NORWALK LA MIRADA UNIFIED SCHOOL DISTRICT
LA MIRADA HIGH SCHOOL NEW FOOTBALL STADIUM PROJECT
13520 ADELA DRIVE, LA MIRADA, CA 90638

ADDENDUM 1

ENLARGED SITE PLAN

A1.02

TRUE NORTH
PLAN NORTH
1 ENLARGED SITE PLAN
Scale: 1" = 30'-0"

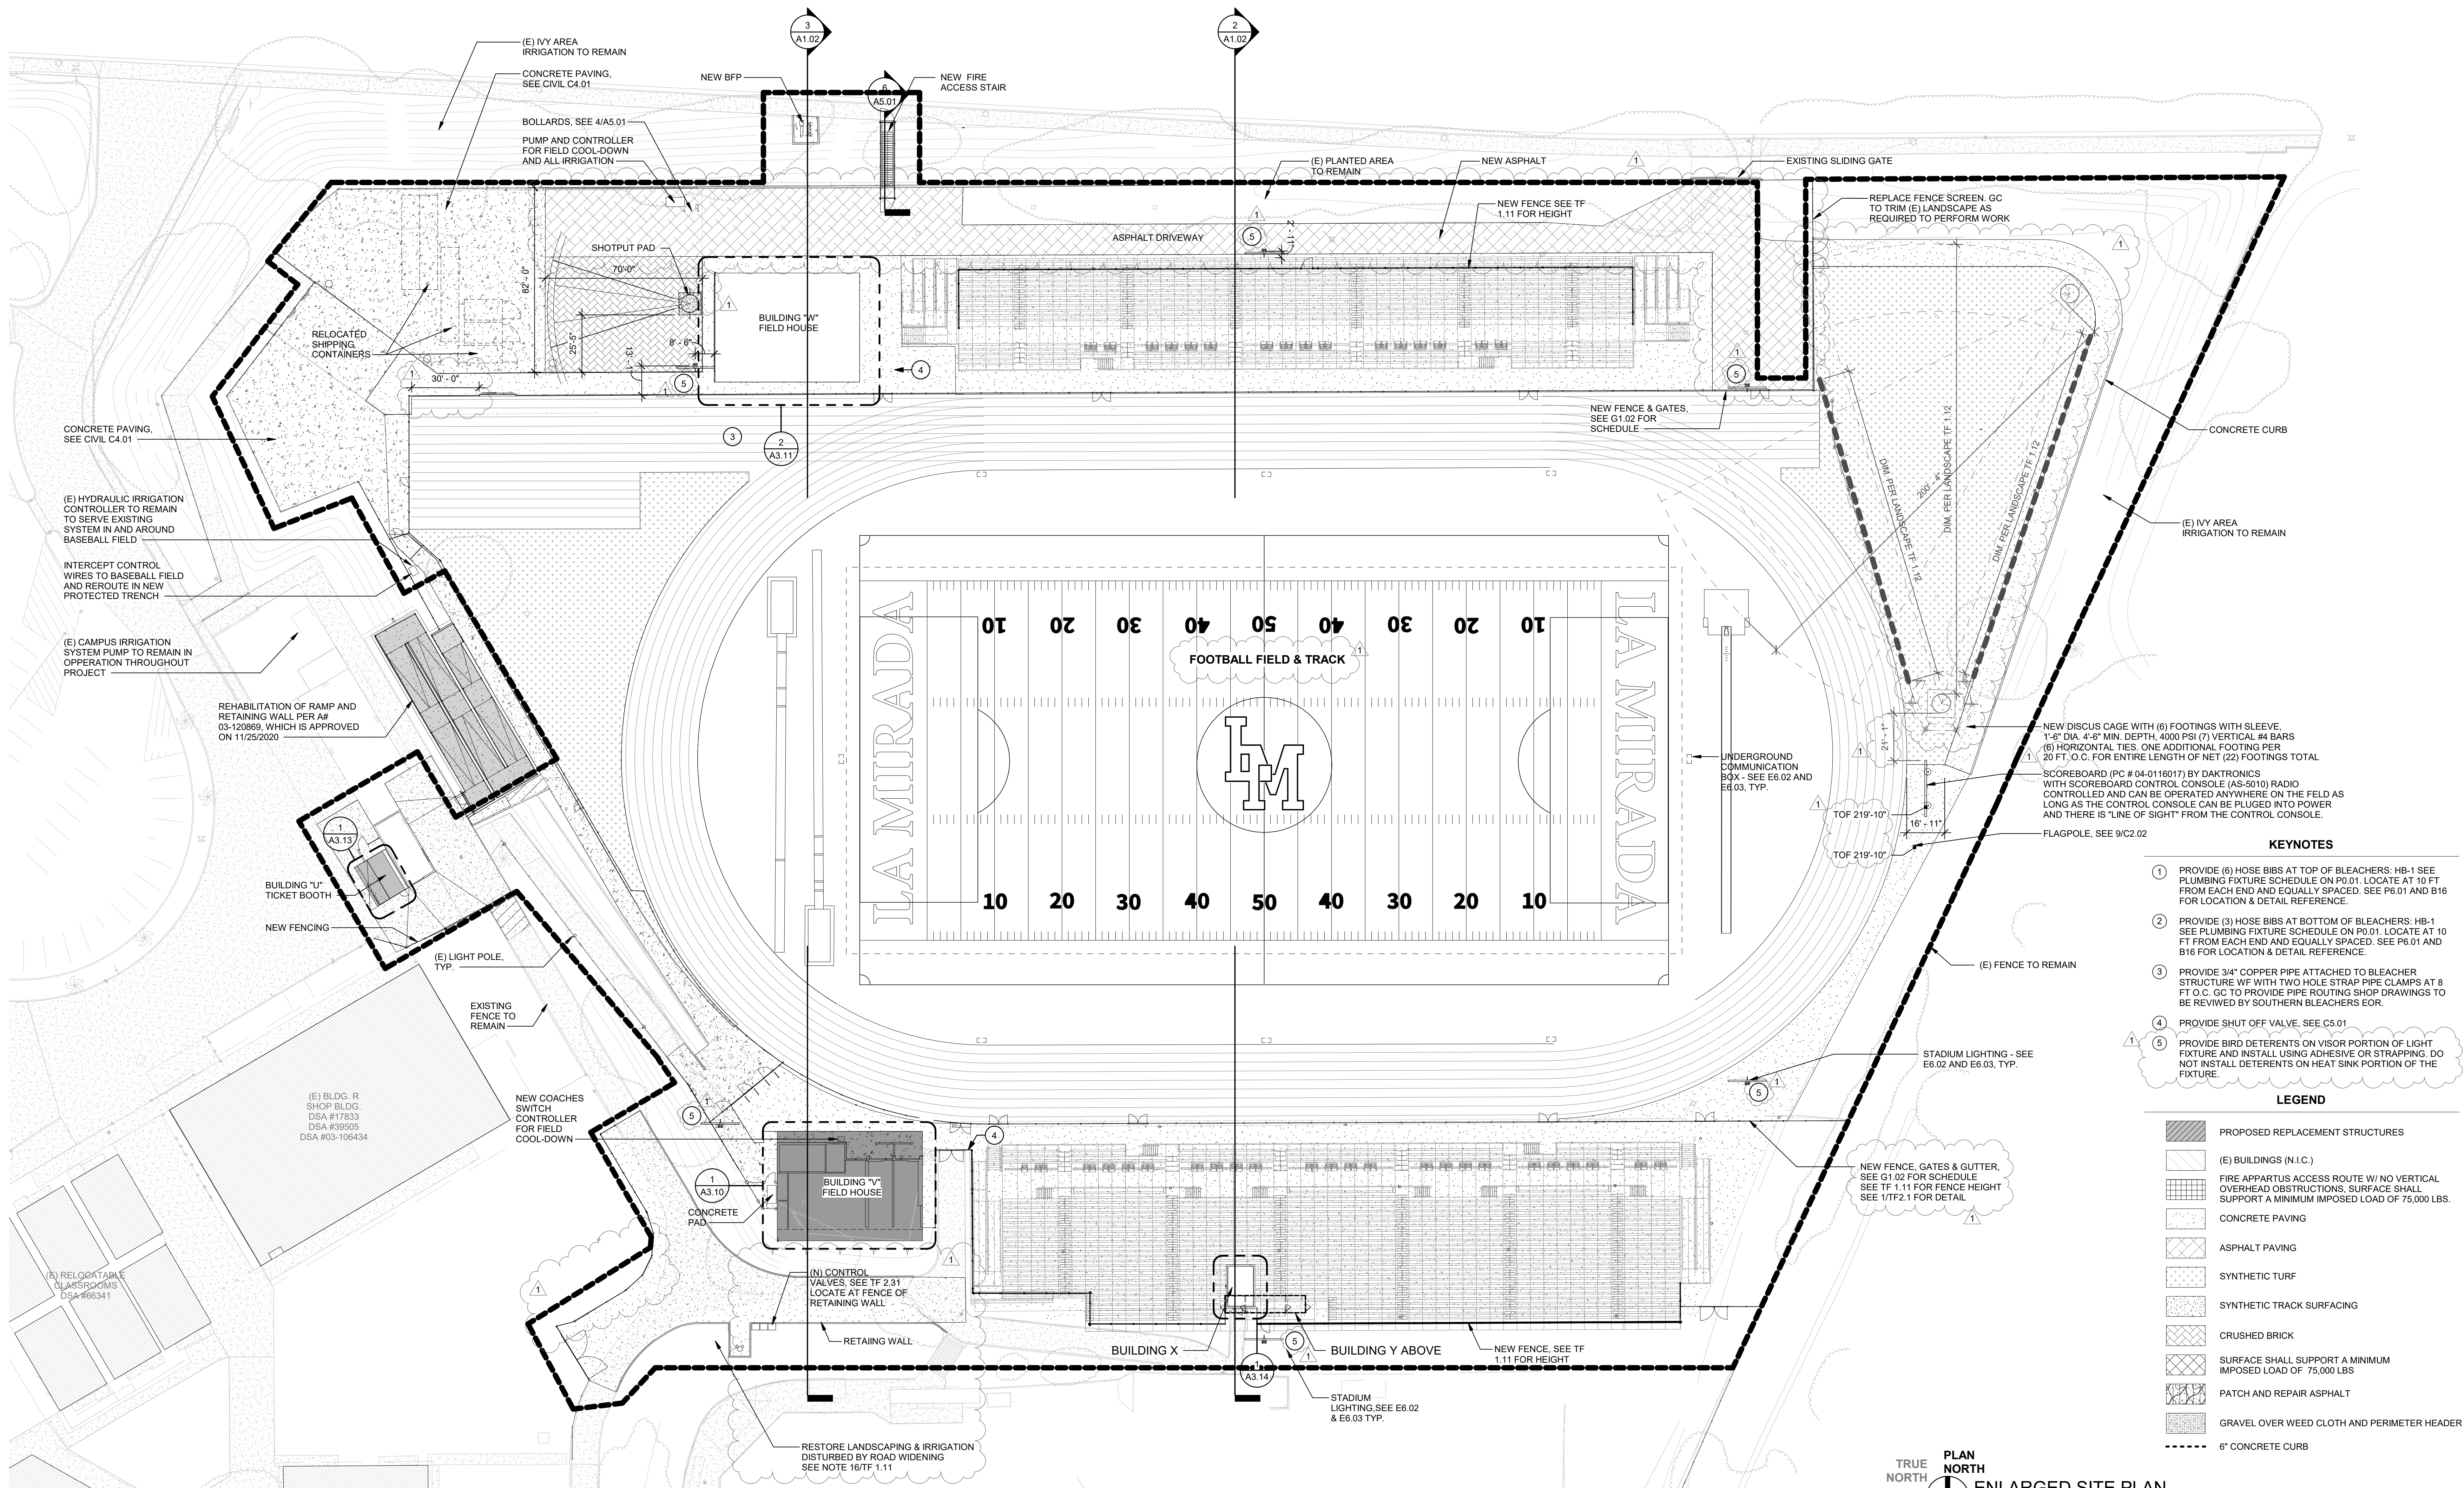
- KEYNOTES**
- PROVIDE (6) HOSE BIBS AT TOP OF BLEACHERS: HB-1 SEE PLUMBING FIXTURE SCHEDULE ON P0.01. LOCATE AT 10 FT FROM EACH END AND EQUALLY SPACED. SEE P6.01 AND B16 FOR LOCATION & DETAIL REFERENCE.

- PROVIDE (3) HOSE BIBS AT BOTTOM OF BLEACHERS: HB-1 SEE PLUMBING FIXTURE SCHEDULE ON P0.01. LOCATE AT 10 FT FROM EACH END AND EQUALLY SPACED. SEE P6.01 AND B16 FOR LOCATION & DETAIL REFERENCE.

- PROVIDE 3/4" COPPER PIPE ATTACHED TO BLEACHER STRUCTURE WF WITH TWO HOLE STRAP PIPE CLAMPS AT 8 FT O.C. GC TO PROVIDE PIPE ROUTING SHOP DRAWINGS TO BE REVIEWED BY SOUTHERN BLEACHERS FOR.

- PROVIDE SHUT OFF VALVE. SEE C5.01
 - PROVIDE BIRD DETERENTS ON VISOR PORTION OF LIGHT FIXTURE AND INSTALL USING ADHESIVE OR STRAPPING. DO NOT INSTALL DETERENTS ON HEAT SINK PORTION OF THE FIXTURE.
